STAFF REPORT FOR THE PLANNING COMMISSION MEETING OF APRIL 27, 2016.

FILE NO.: VAR-16-022 & SUP 16-021

(A) VAR-16-022 - To consider a request from Bella Lago, LLC (property owner Bella Lago, LLC) for a Variance to allow the reduction of required open space per unit for residential development in a non-residential zoning district on property zoned General Commercial (GC).

(B) SUP-16-021 - To consider a request from Bella Lago, LLC (property owner Bella Lago, LLC) for a Special Use Permit to allow the addition of 64 multifamily apartments within the existing 175-unit Bella Lago Apartment complex on property zoned General Commercial (GC).

REV	DATE	DESCRIPTION	BY
1	4/7/2010	MODIFICATION PER FIRE DEPT COMMENTS	CAB

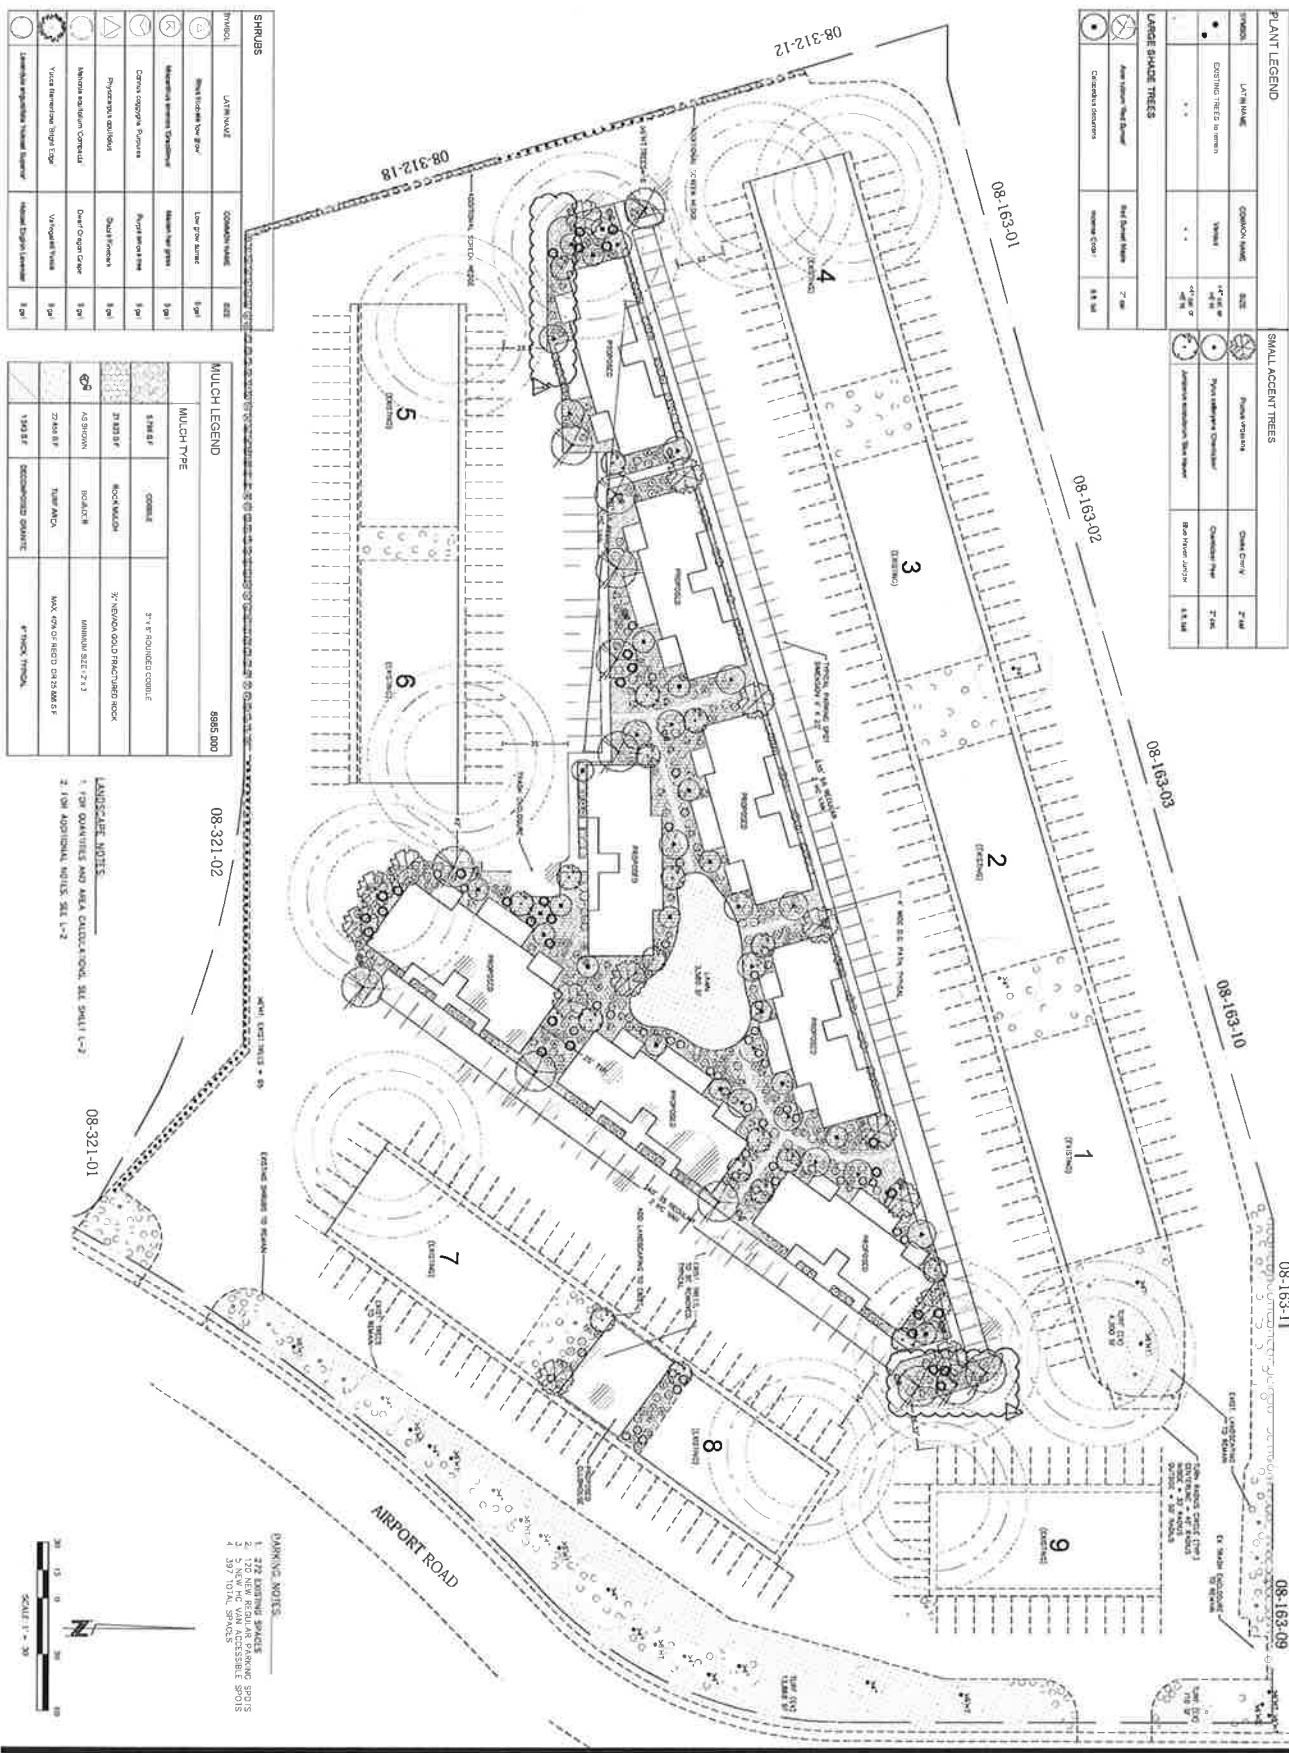
Hope was going to add something regarding the updated drawing Lumos sent for the turning radius in the parking lot.

Let's use this as its clearer: The construction plans must demonstrate turning radii for the fire access lanes around the new buildings of a minimum of 30' inside and 50' outside.
